Project	IEEE 802.16 Broadband Wireless Access Working Group < http://ieee802.org/16 >	
Title	Changes in the 802.16 Fragmentation and Packing Function	
Date Submitted	2001-05-11	
Source(s)	Vladimir Yanover BreezeCOM Ltd. 21 A Habarzel St. Ramat - Hahayal Tel - Aviv 69710, Israel	E-Mail: vladimiry@breezecom.co.il Tel.: +972-36457834 Fax: +972-36456290
Re:	This document is submitted for a discussion on the "Advanced Packing" section of TG3 MAC Document	
Abstract	This document figures the suggested changes in the 802.16 Fragmentation and Packing Function	
Purpose	The document is submitted as a part of development of 802.16a and 802.16b MAC sections. It is for the discussion on the specific details of Fragmentation and Packing requested by the TG3/TG4 applications	
Notice	This document has been prepared to assist IEEE 802.16. It is offered as a basis for discussion and is not binding on the contributing individual(s) or organization(s). The material in this document is subject to change in form and content after further study. The contributor(s) reserve(s) the right to add, amend or withdraw material contained herein.

Changes in the 802.16 Fragmentation and Packing Function

Vladimir Y

Figure 1. Fragmentation Sub-header

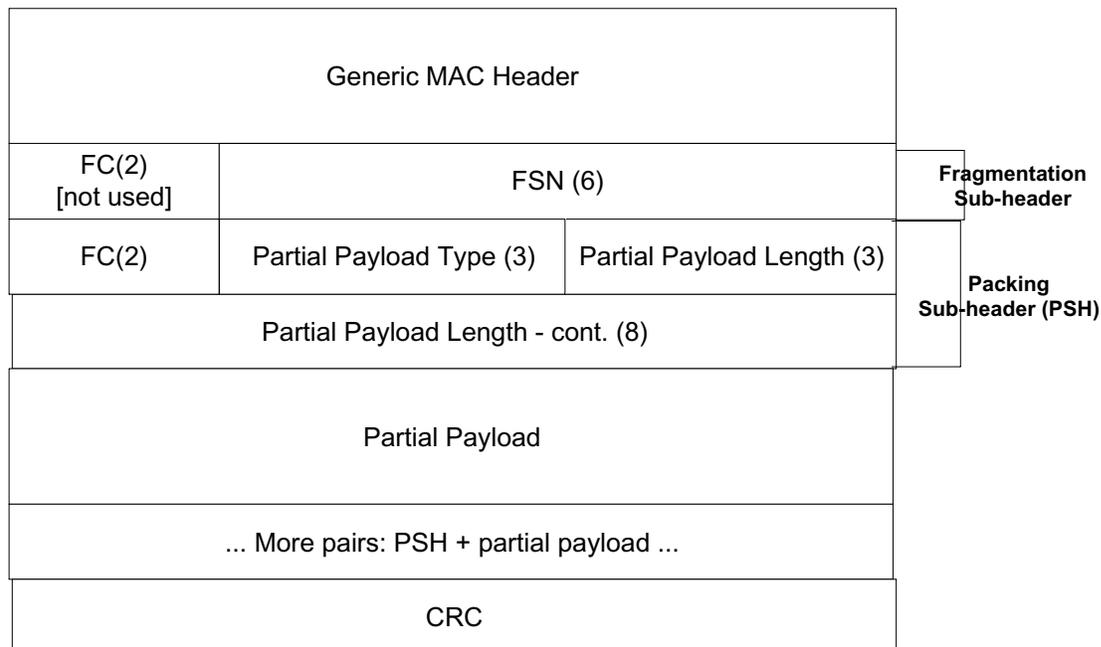
For TG3 / TG4 applications BER is not expected to be that as low, there may be bursts of errors, so we need more strong mechanism that would encounter errors in the delivery of segments. Such a mechanism can be built simply by enlarging the number of bits in the FSN. In the document [1] it is proposed to use (for the needs of ARQ) the following new format of sub-header

If we follow certain rules (transmit window restrictions) we can ensure absolutely secure algorithm of reassembling.

It is suggested to replace the format of the Fragmentation Sub-header from the section 6.2.2.2.1 Fragmentation Sub-header [2] to the figured above so that such format would be valid also for the connections with ARQ disabled.

In the case of ARQ enabled, this field may either remain a Fragment Sequence Number or have another meaning (depends on ARQ definition which still is TBD).
